From: [Stephen Ubl](#)
To: [Marcia Moermond](#)
Cc: [Nathan Bruhn](#)
Subject: FW: 733 Fairview Ave. N.
Date: Monday, March 11, 2024 1:04:54 PM
Attachments: [image005.png](#)
[image006.png](#)
[image007.png](#)
[image008.png](#)
[image009.png](#)
[image010.png](#)

I have been told that you are engaged in a project at 733 Fairview Ave. N., a building identified as a Vacant Building Category III. If you have questions regarding Plan Review, Permitting, Inspections, or Appeals, please reach out to me and I can see what I can do to move this project along.

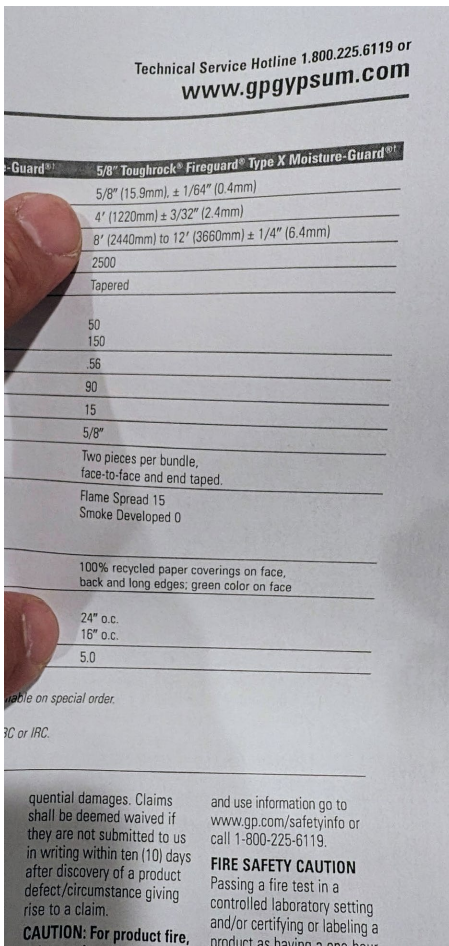
To this end, as illustrated in the Georgia-Pacific manufacturer's installation recommendation instructions for the 5/8" Toughrock Fireguard ("green" board) Type X Moisture Guard gypsum sheetrock that has been installed in the 733 basement ceilings, Framing Spacing, Maximum for Ceilings is **16" o.c., not 12" o.c.**

To this end, the basement 5/8" ceilings at the 733 Fairview Ave. N. property remain in compliance with both the CertainTeed ("purple" board) and the Georgia-Pacific ("green" board) manufacturer's installation recommendations of a minimum of 16" o.c.

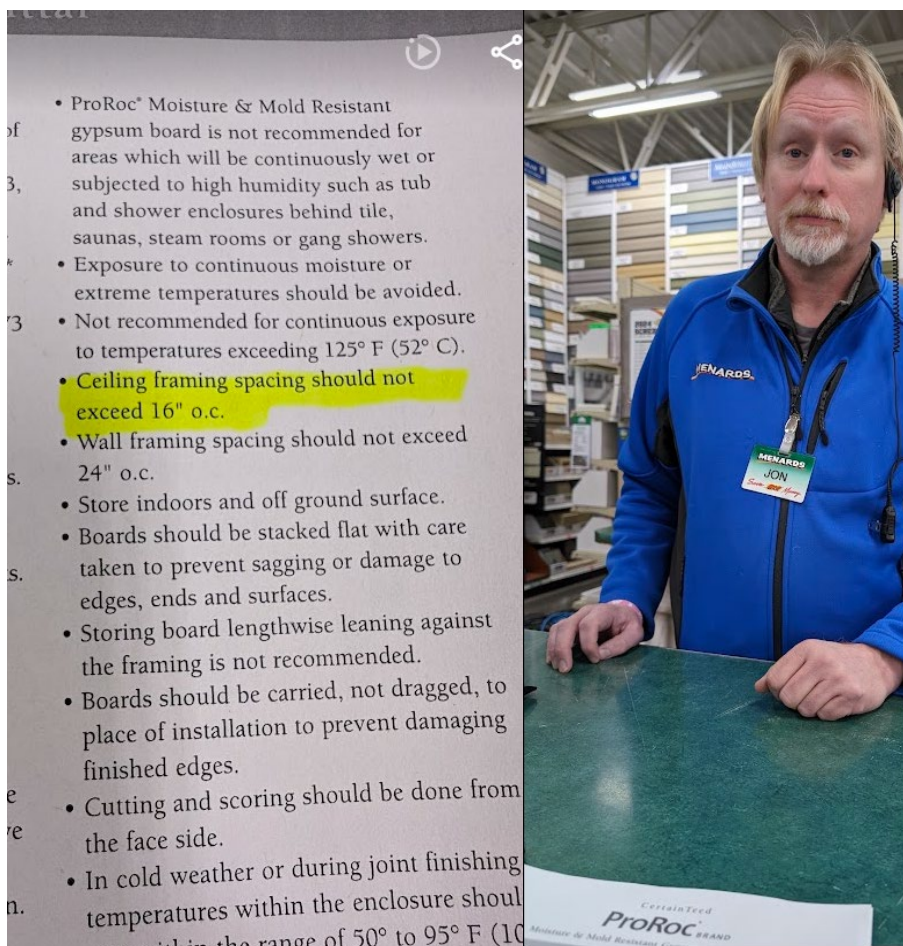
Tuesday, after our meeting, I went to Menards. I eventually was able to speak with Jon, in the building center, who is familiar with my situation. I asked him to provide me with the literature on the manufacturer's installation instructions for the moisture-mold-resistant sheetrock to determine whether what I did in my home complied with the manufacturer's installation recommendations. I asked him specifically whether the moisture & mold resistance gypsum board he sold me from Menards to install on many of the walls and ceilings, per the manufacturer's instructions, called for it to be installed on 16" on center or whether it required a lesser distance. Without saying a word, Jon got on his screen, printed, and with his yellow highlighter, marked the following and slid the paper over to me: **Ceiling framing spacing**

should not exceed 16" o.c." Based on the above, I complied with the manufacturer's gypsum board moisture-mold-resistant installation recommendations, Stephen.
